SUBJECT: Invitation for Bid #10-3586-OV
Southwest Water Reclamation Facility (SWWRF) Improvements
To the Reclaimed Water Automation **AND** Southeast Water
Reclamation Facility (SEWRF) Improvements to the Reclaimed
Water Automation and VFD Replacement

ADDENDUM #3

**Manatee County
SEWRF Reclaimed Water Automation Project And VFD Replacement (#6013792)
SWWRF Reclaimed Water Automation (#6016392)**

Addendum No. 3**December 17, 2010**

(12-15-10) Revised M-3 Add #3

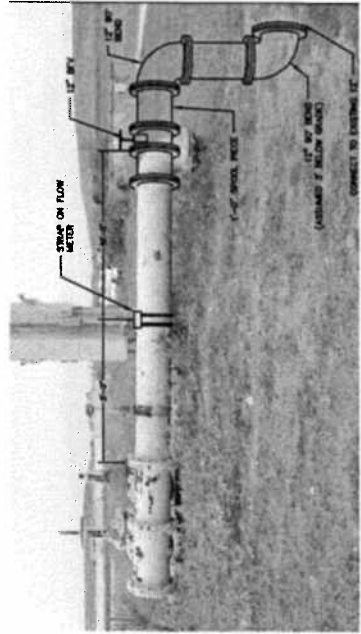
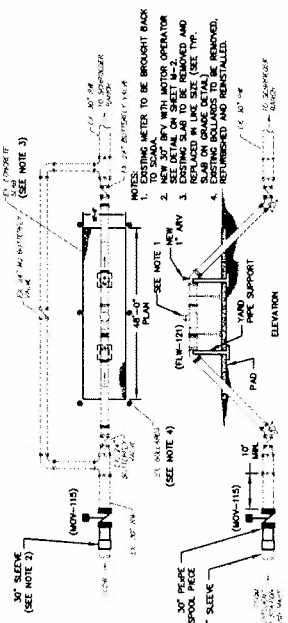
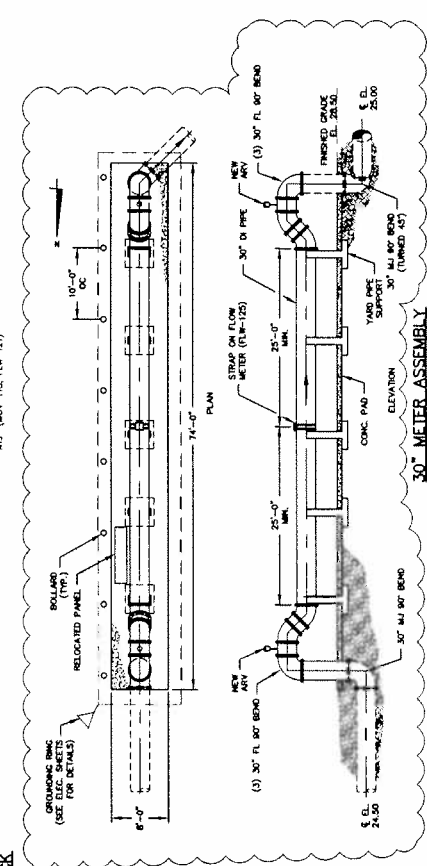
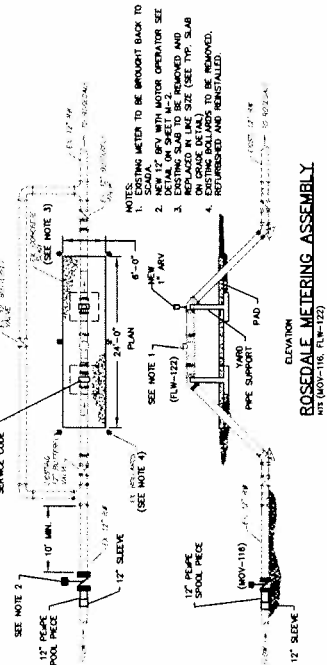
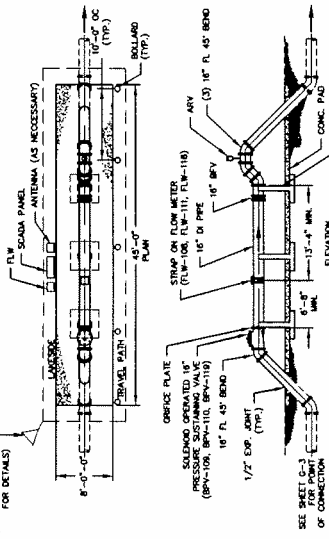
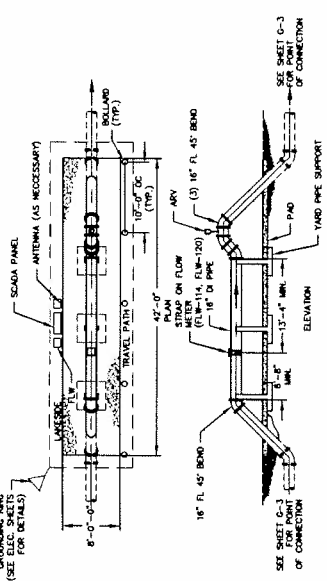
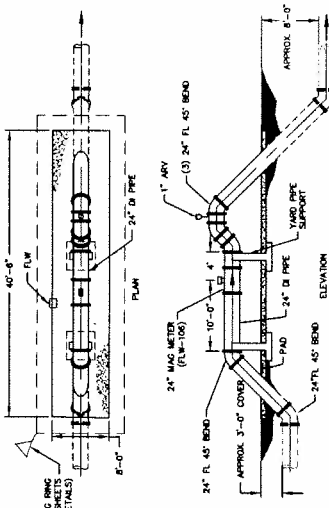
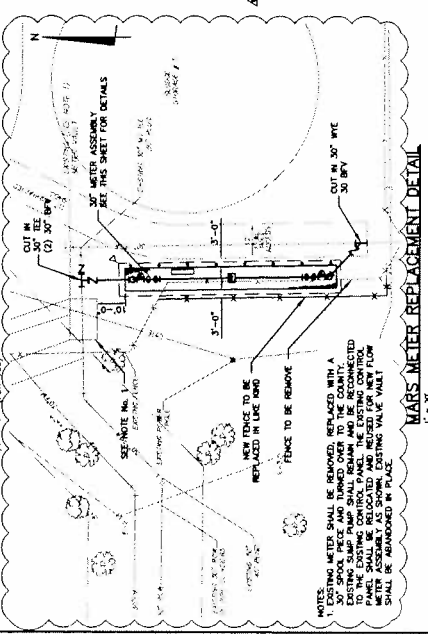
1. Drawing M-3, delete this sheet and replace it with the attached drawing M-3, Revision 1.

6. **Question:** Please provide scaled drawing or linear footage of fence to be removed and installed at the MARS meter. (Dwg M-3 is not to scale).
Response: The scale for the MARS Meter Replacement Detail has been adjusted and noted on the revised drawing M-3. See Part I of this addendum for response.

Response: The underground valve shown in the plan view for the New 16" Meter Assembly detail has been removed. See Part I of this addendum for response.

10. **Question:** SEWRF-Plan M-3 middle of page, new 16" meter assembly with back pressure sustaining valve, is the underground valve new or existing?
Response: The underground valve shown in the plan view for the New 16" Meter Assembly With Back Pressure Sustaining Valve detail has been removed. See Part I of this addendum for response.

Figure 1
Add # 3

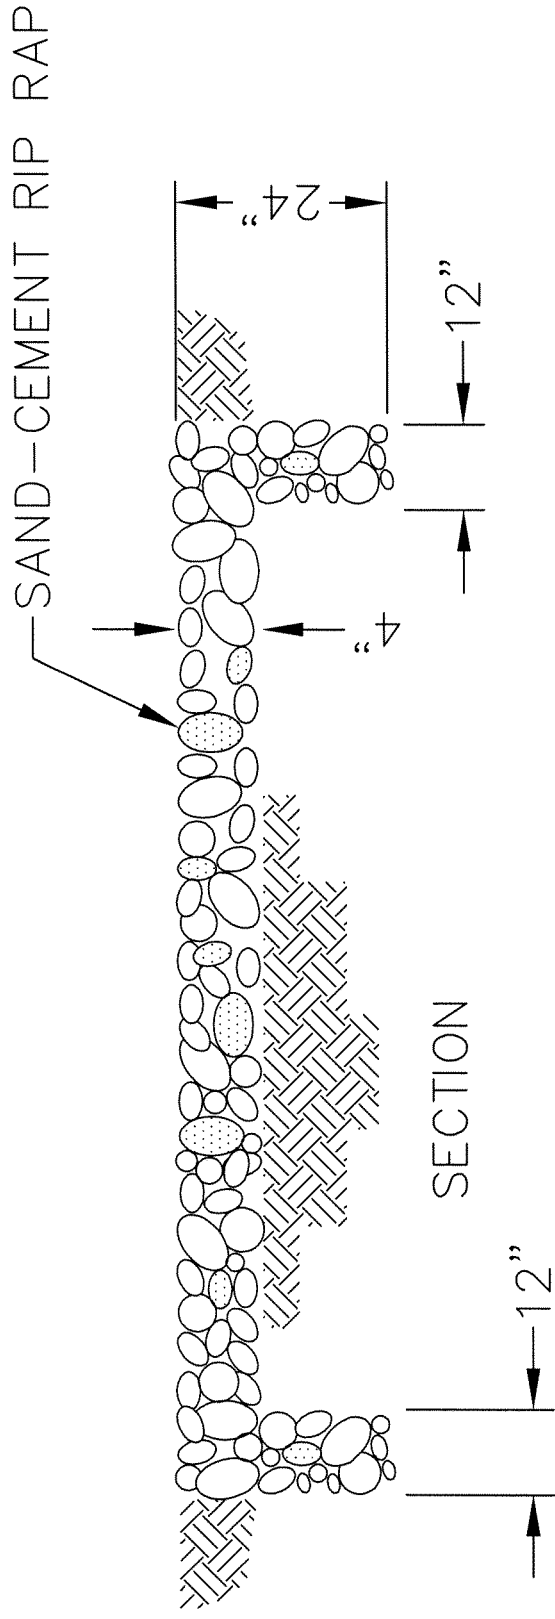
1. **Question:** Please provide material details of Rip Rap at the north pond in SWWRF.
Response: See Figure 1 attached for illustration. Materials shall be sand-cement rip rap with a 4" minimum depth. The rip rap shall be turned down along all edges with a minimum thickness of 12" and a minimum depth of 24".

Figure 2
Add #3

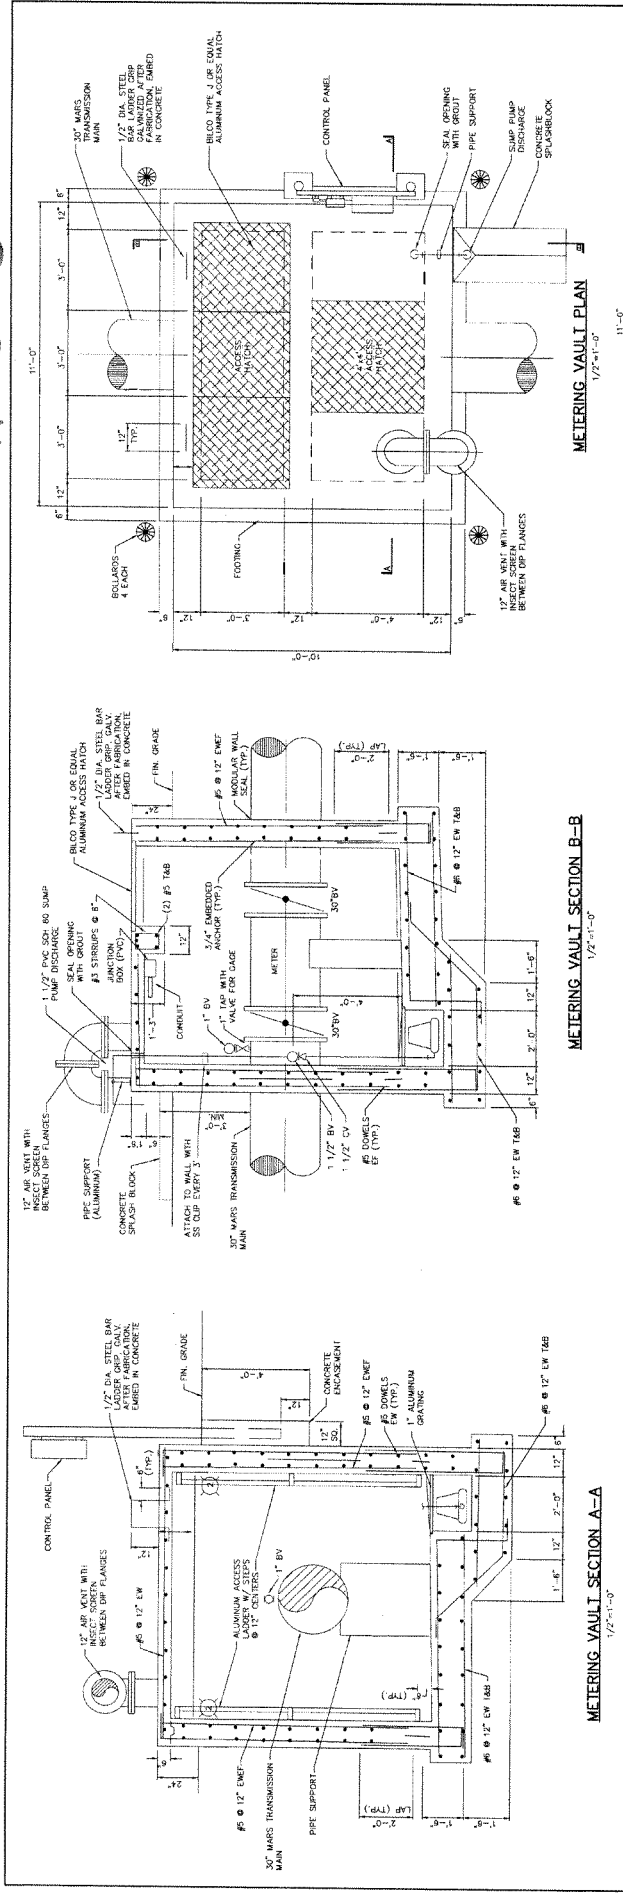
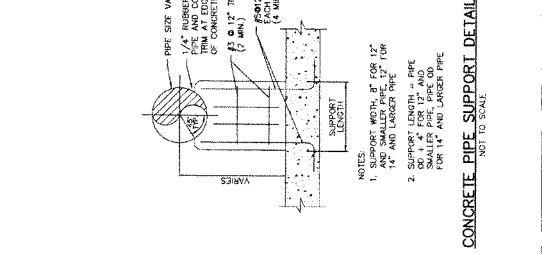
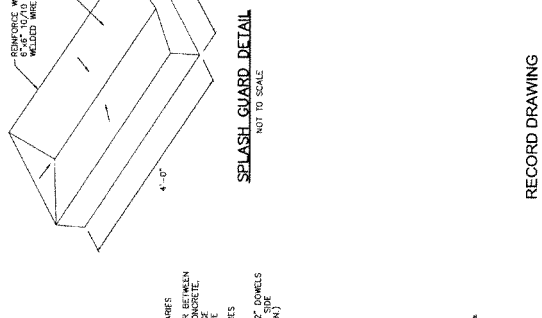
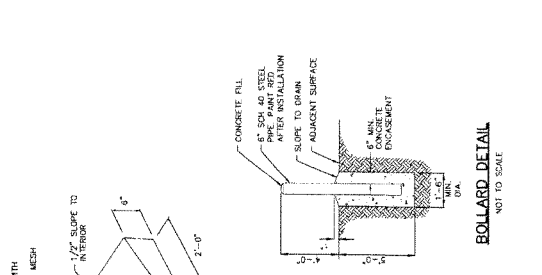
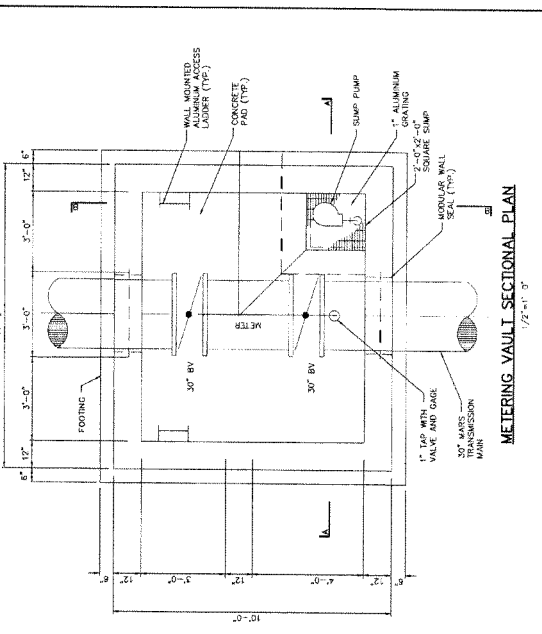
5. **Question:** On SEWRF Dwg M-3, Note 1, for MARS meter replacement refers to existing vault to be removed. Provide size or details for this vault and piping within.

Response: See Figure 2 (Construction Drawing C-28) attached for details of MARS metering vault. The figure is not to scale; however, all relevant sizes and dimensions are called out on the drawing.
